IMPORTANT SAFETY RECALL

Subject: Safety Recall Notice NHTSA Recall No. 15V-155

Checking the Tie Rod End Castle Nut Torque on Meritor Bus and Coach Non-Drive Steer and Tag Axles

MFS12155ANL16, FH946KX5, FH946KX41 and FH946KX52 Models Produced from 7-19-2014 through 12-5-2014

Figure 1

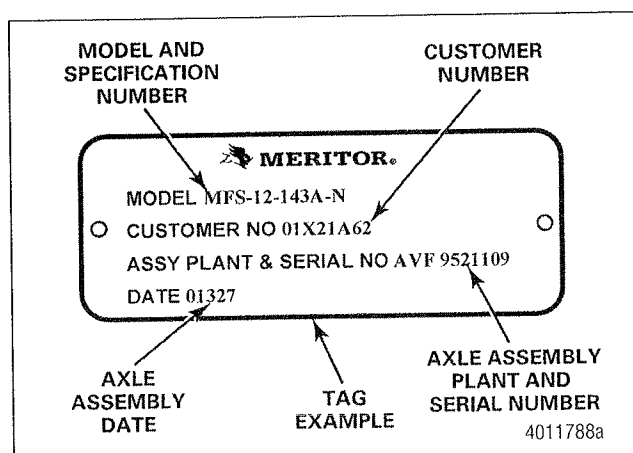
This technical bulletin provides instructions to check the torque and, if required, tighten the tie rod end castle nuts on MFS12155ANL16, FH946KX5, FH946KX41 and FH946KX52 models produced from 7-19-2014 through 12-5-2014. Instructions are also provided to inspect and replace the tie rod arms and tie rod ends, if required. Figure 1.

NOTE: The date is in a Julian date format. Example: 01327 = 327th day of 2001 or 11-23-2001.

Figure 2

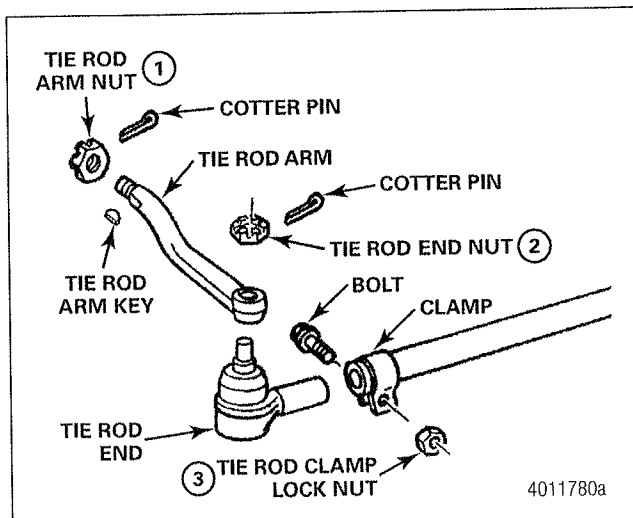
1. Wear safe eye protection. Park the vehicle on a level surface.
2. Place blocks under the wheels not being serviced to keep the vehicle from moving.
3. Raise the vehicle so that the wheels you will service are off the ground. Support the vehicle with safety stands.
4. Remove the cotter pin that secures the tie rod end castle nut to the tie rod arm. Figure 2.

Item	Description	Size	Torque Range in Lb-Ft (N•m)
1	Tie Rod Arm Nut	1.250"-12	775-1450 (1051-1965)
2	Tie Rod End Nut	0.875"-14	160-300 (217-407)
3	Tie Rod Clamp Lock Nut	0.750"-10	155-175 (210-237)

Figure 3

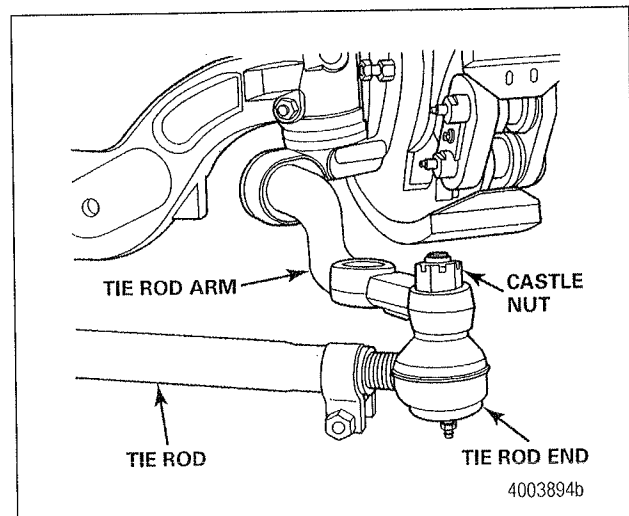
5. Place a calibrated torque wrench on the tie rod end castle nut.
6. As a verification check to ensure the castle nuts are not hand loose or below 25 lb-ft (34 N•m), set the torque wrench to 25 lb-ft (34 N•m). Rotate the tie rod end castle nut in a clockwise direction and note if the nut turns before reaching the set torque. Figure 3.

- If the tie rod end castle nut does not rotate prior to reaching 25 lb-ft (34 N•m): Proceed to Step 7.
- If the tie rod end castle nut rotates prior to reaching 25 lb-ft (34 N•m): Remove the castle nut and tap the tie rod arm with a brass or leather mallet to check the taper lock. Note it is not necessary to strike the tie rod arm hard to perform this check. On some axles, the ball stud may be mounted above the tie rod arm. In such case, lift up on the tie rod end to verify the taper lock. The taper lock should not separate when the tie rod arm is tapped. The two parts should be locked together.

7. Install the tie rod castle nut and tighten to 160 lb-ft (217 N•m).

8. If the hole for the cotter pin is not aligned, tighten the castle nut to align the next available hole in the nut. Do not loosen the nut to align the cotter pin hole. Install a new cotter pin, part number K-2412 (1/8" x 1.5").
9. The torque check of the castle nut is complete. Repeat the procedure on the opposite side of the vehicle.
